**Comments On The Thermal-Hydraulic Analysis In
NUREG-1570**

**ACRS Materials and Metallurgy Subcommittee
& Severe Accidents Subcommittee**

March 5, 1997

**Joe Hopenfeld
GSIB/DET/RES**

MIXING OF STEAM STREAMS IN THE INLET SG PLENUM

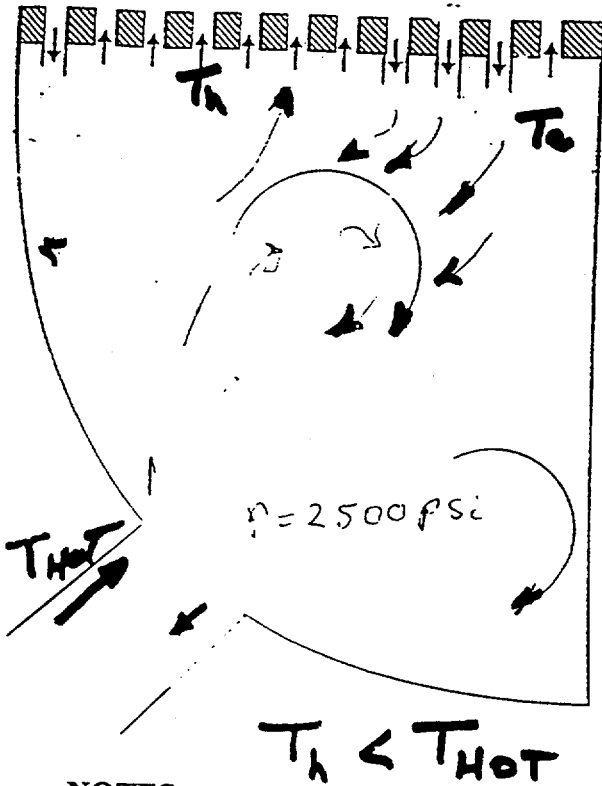
- (1) Flow from leaking tubes into the secondary side
- (2) Return flow from outlet plenum
- (3) Forced convection flow (leakage)
- (4) Free convection flow (buoyancy)
- (5) Counter flow (hot)
- (6) Counter flow (cold)
- (7),(8) Wall flow due to local temperature differences

Leaking Tubes Flow, (1) = 10 - 250 Lbs/sec
Counter Flow, (5) = 4 Lbs/sec

- Comparison between mixing (left) and non mixing models (right).
- No mixing results from high leakage (right)

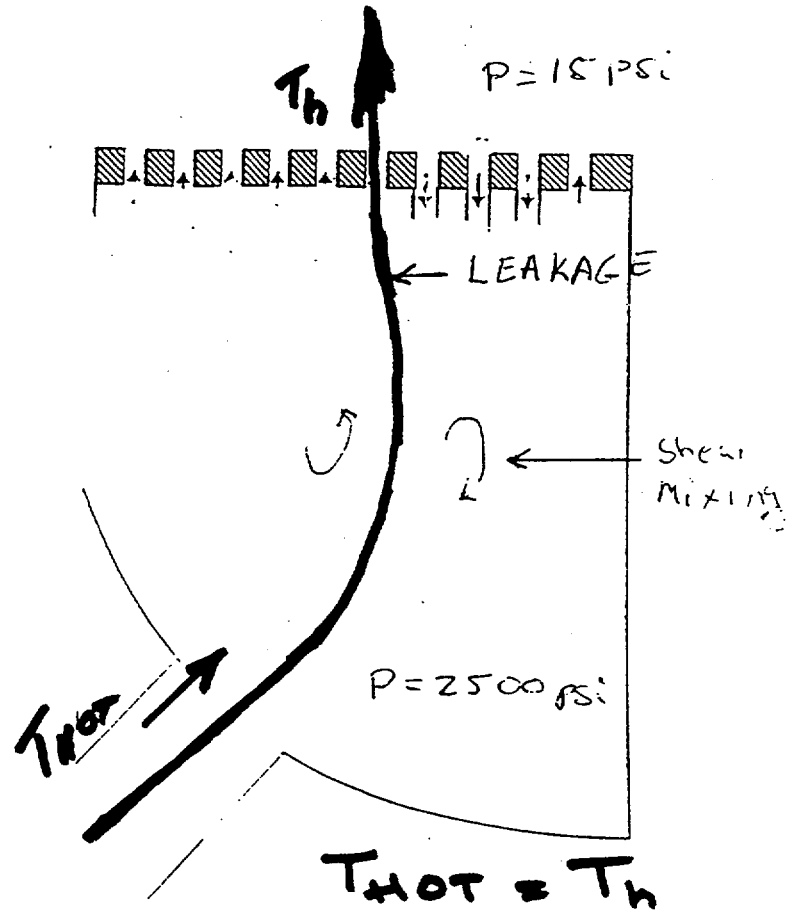
- Mixing decreases tube temperature rise rate in comparison to the non mixing case
- NUREG analysis is based on 1/7th scale tests where there was no leakage
- Sensitivity studies which are based on 1/7th scale test data have no physical meaning. If the tests were conducted with leakage the flow pattern would have been different
- Varying the number of hot tubes and circulation ratios may be applicable when the counter flow is larger than tube leakage.

Schematic of Tube to Tube Propagation Due to 0.001" Thru Wall Defect

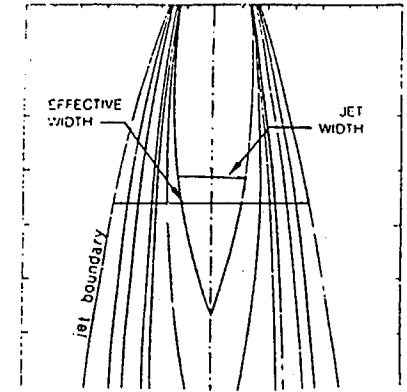
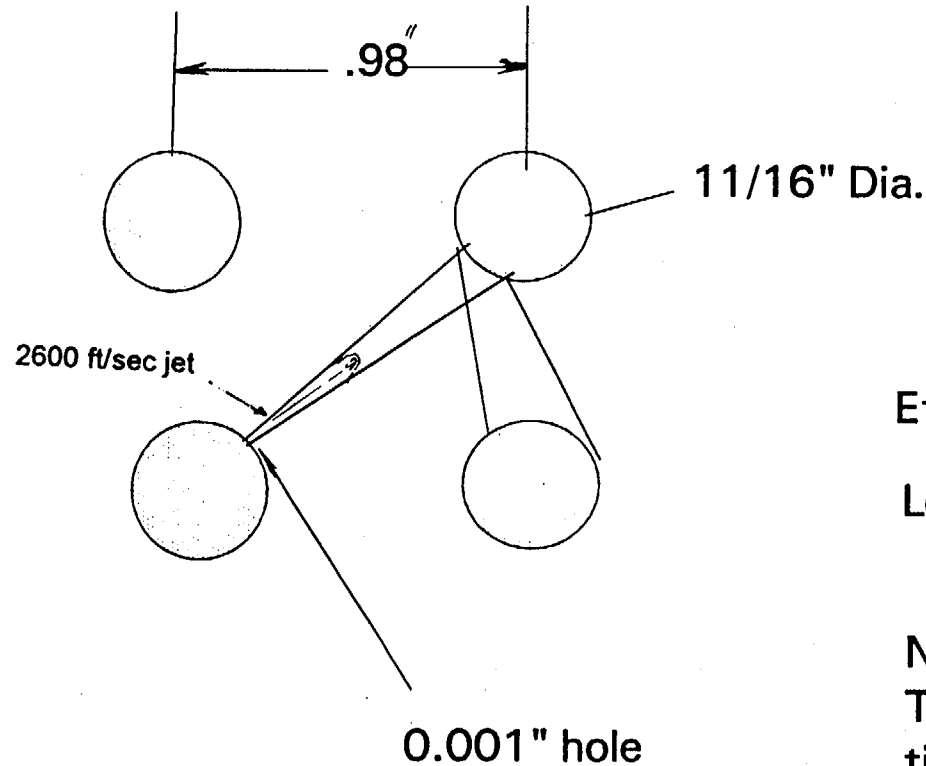
- (1) Tube to Tube Damage May Propagate Very Fast
- (2) Damage to Four Tubes is a Reasonable Assumption
- (3) 4 Tube Equivalent Leakage = 260 lbs/sec
